PCN: V14-005-00475504-OA

Product Change Notice

Change Type #1: Alternate LED supplier

Change Type #2: Alternative supplier for stacked PCB

Figure 1: Internal layout comparison between current LED and new LED.

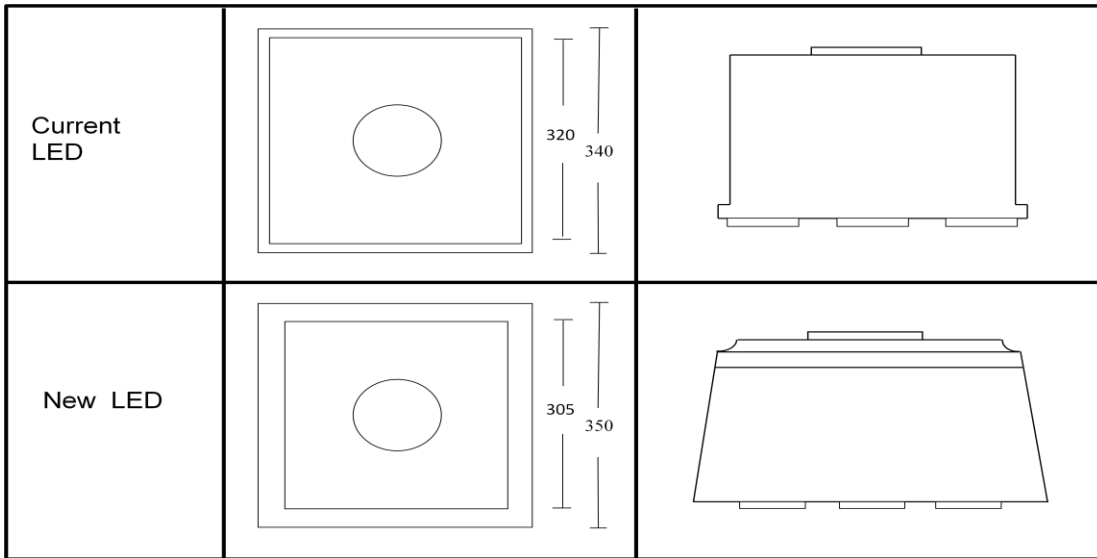
The photos below show the internal layout of the product for both LEDs. The slant wall of new LED is due to different wafer fabrication process, and doesn't affect electrical performance of the product. There's no change to the dimensions of the package.

Figure 1: Comparison of the current and new PCBs.

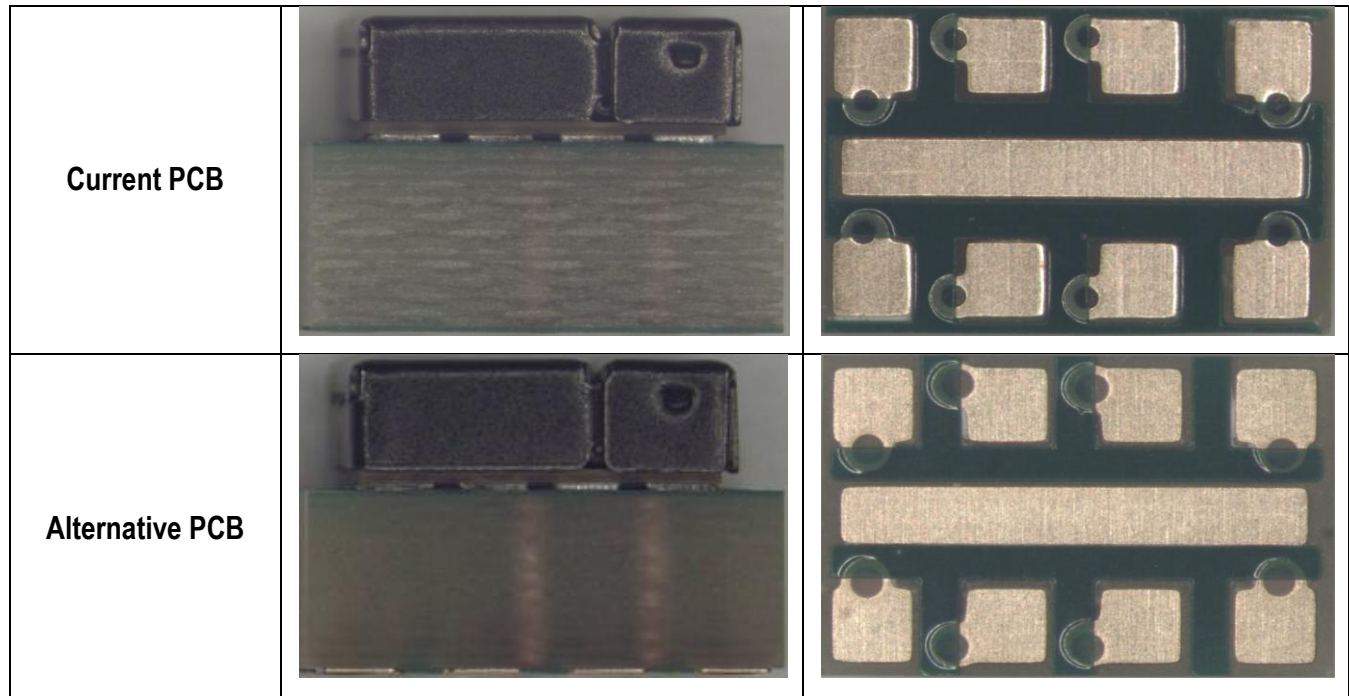
The photos below shows the exterior package of the current devices produced, and compared to the new changed part.

The change does not affect the size and dimension of the package. There is no change to the datasheet.
